**PROJECT NO. TMUA-W 25-07 SPAVINAW STEM WALL
MAINTENANCE**

**ADDENDUM NO. 1
TO
PROJECT NO. TMUA-W 25-07 SPAVINAW STEM WALL MAINTENANCE**

ADDENDUM 1, dated October 17, 2025

DETAILS			
TMUA-W-25-07			
SPAVINAW STEM WALL MAINTENANCE			
CITY OF TULSA, OKLAHOMA WATER & SEWER DEPARTMENT			
Plans and Estimates Prepared by: KEITHLINE ENGINEERING GROUP 8556 E. 101ST ST., STE C Tulsa, Oklahoma 74133 (918) 369-7911

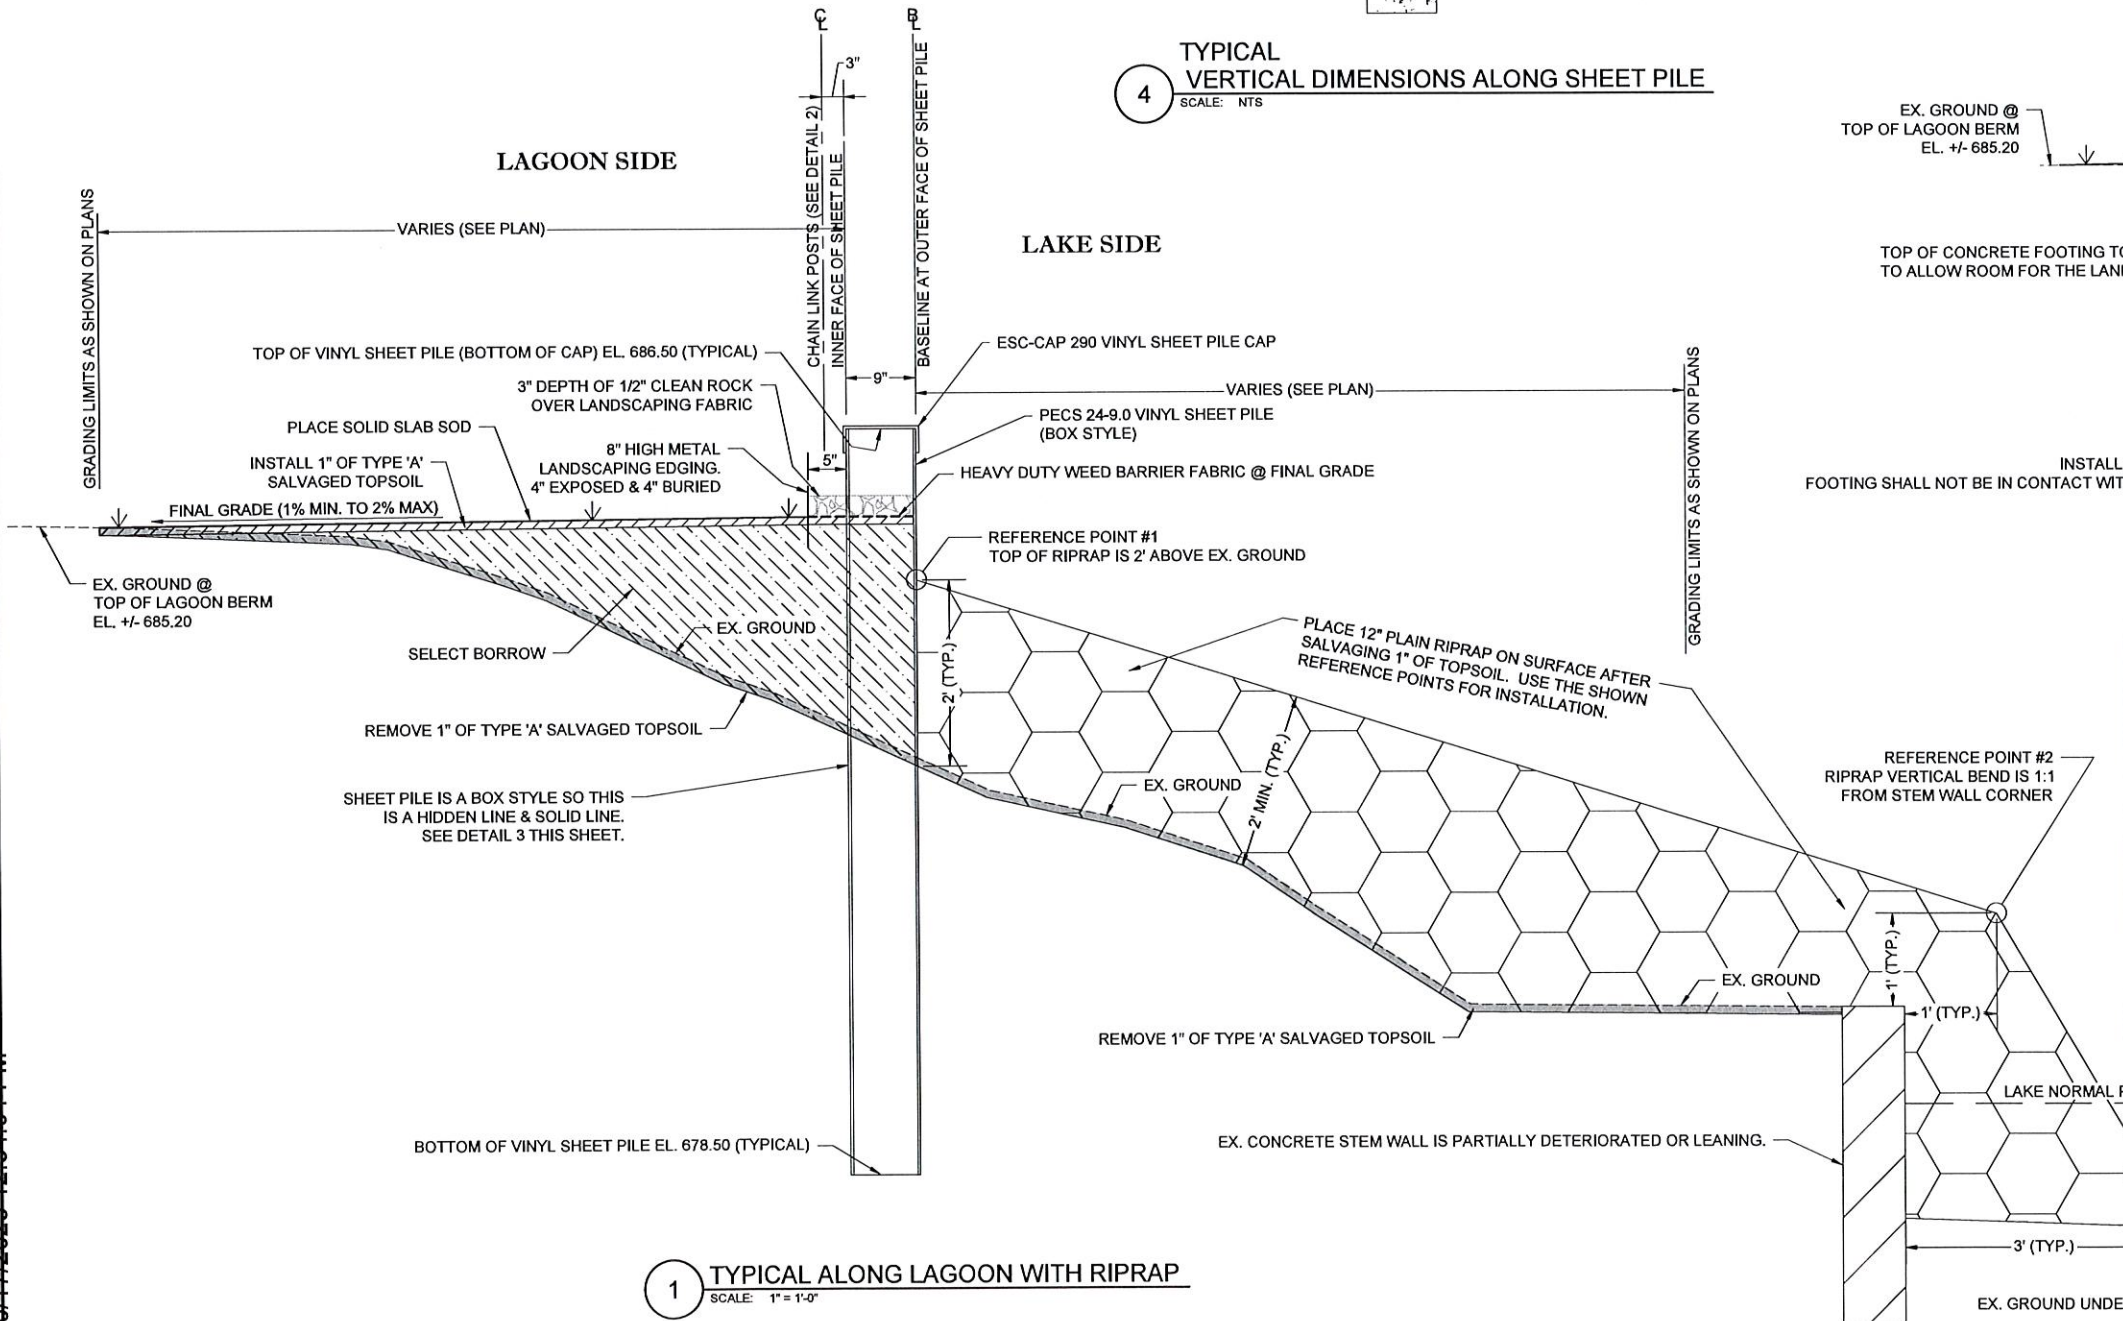
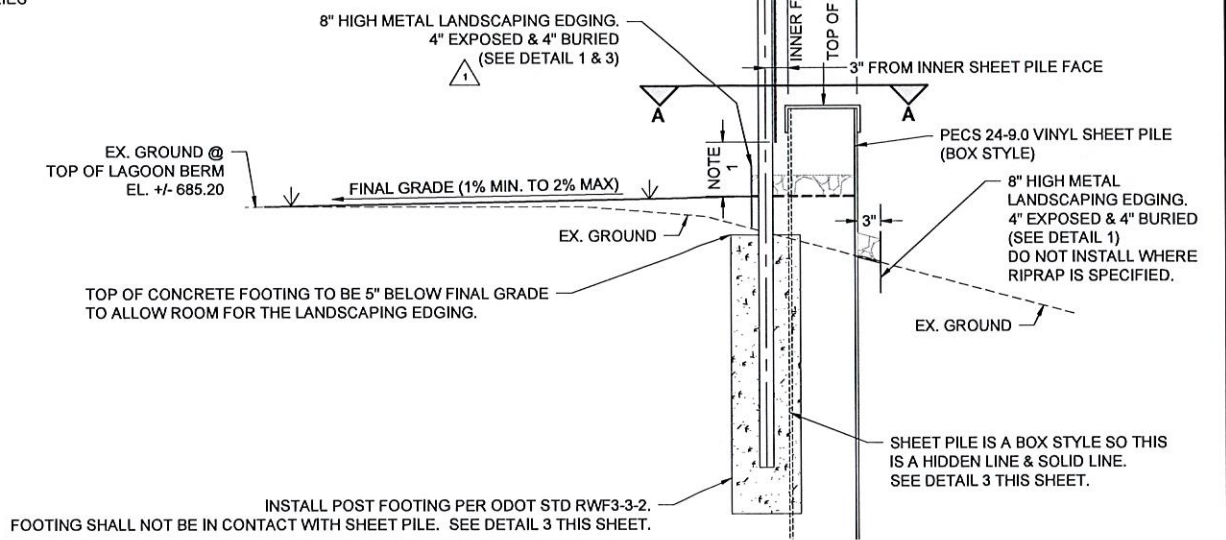
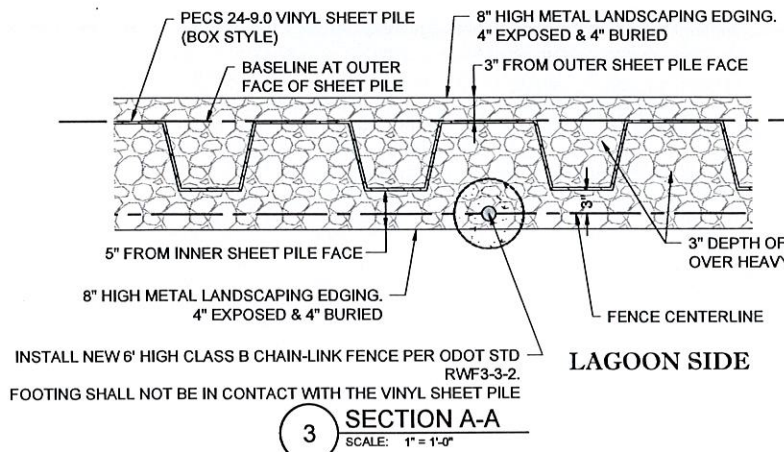
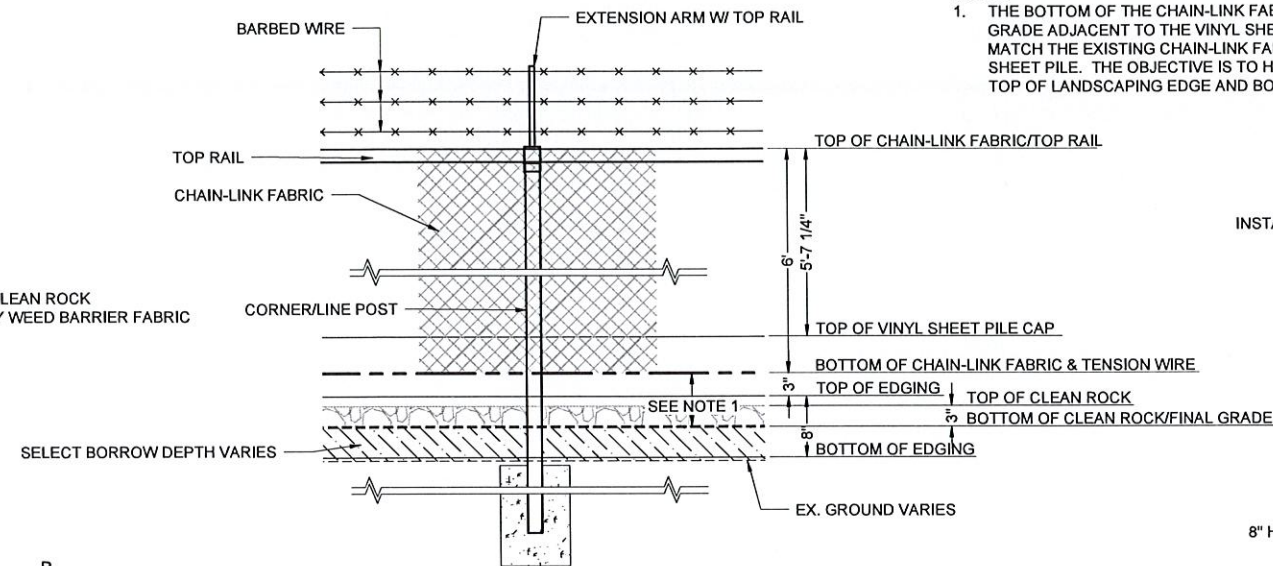
REPLACE SHEET 07 OF 15 WITH MODIFICATIONS LISTED BELOW:

- g. Add additional reference to Detail 2 – Replace (See Detail 1) with (See Detail 1 & 3) per City instructions.

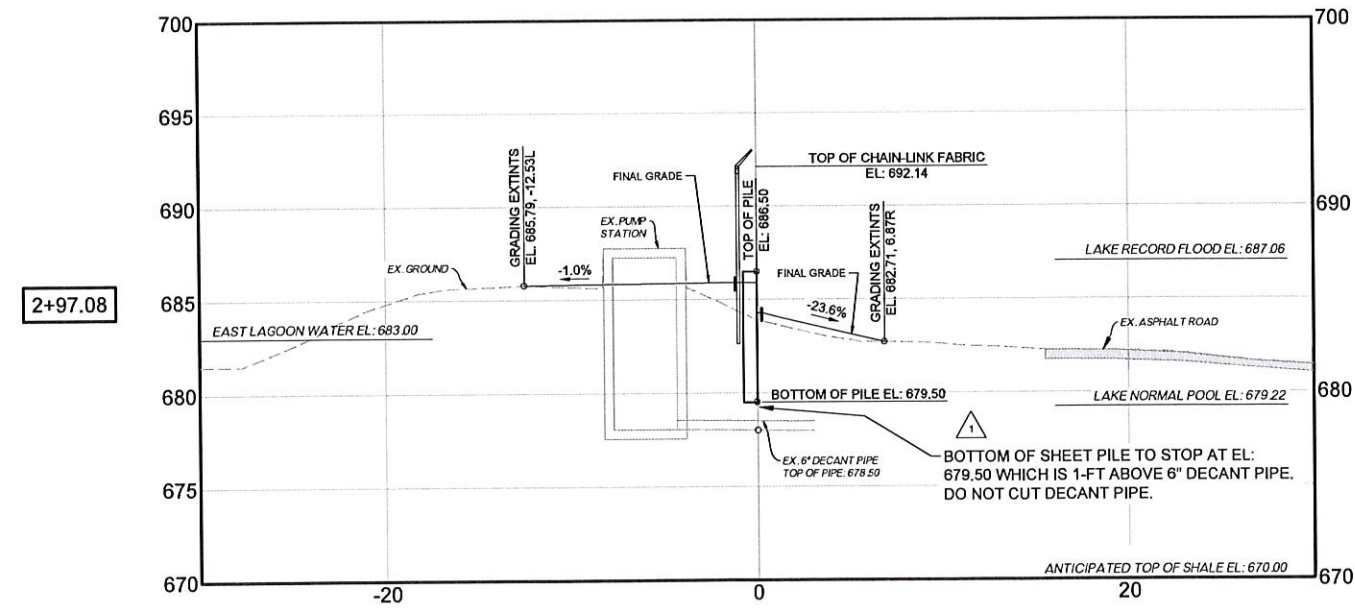
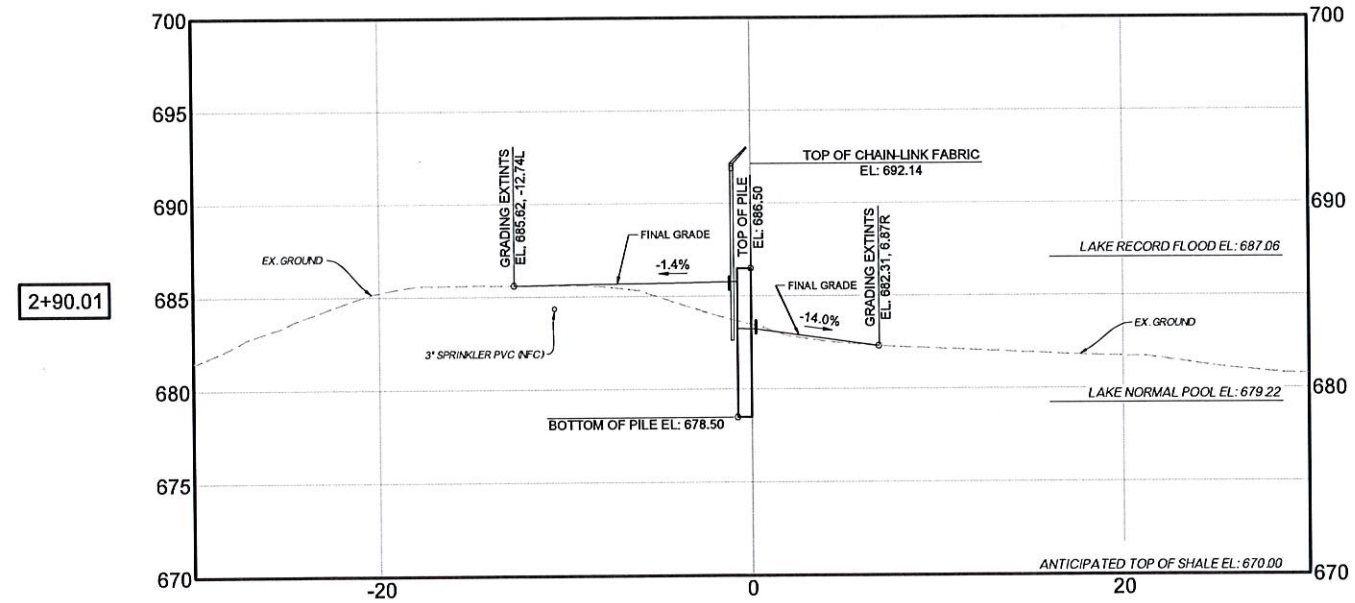
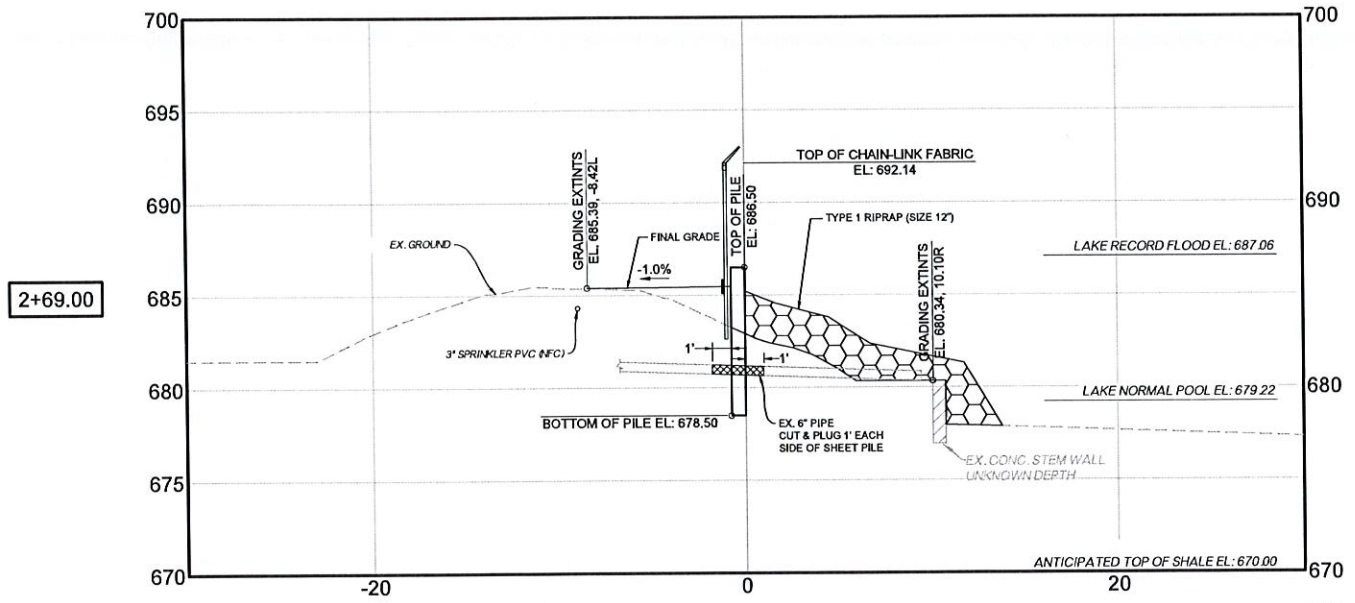
REPLACE SHEET 14 OF 15 WITH MODIFICATIONS LISTED BELOW:

- h. Add additional note at decant line in cross sections, station 2+97. The notes read “Bottom of sheet pile to stop at El 679.50 which is 1-Ft above 6” Decant Pipe. Do not cut decant pipe”. Contractor to field verify all pipe elevations.
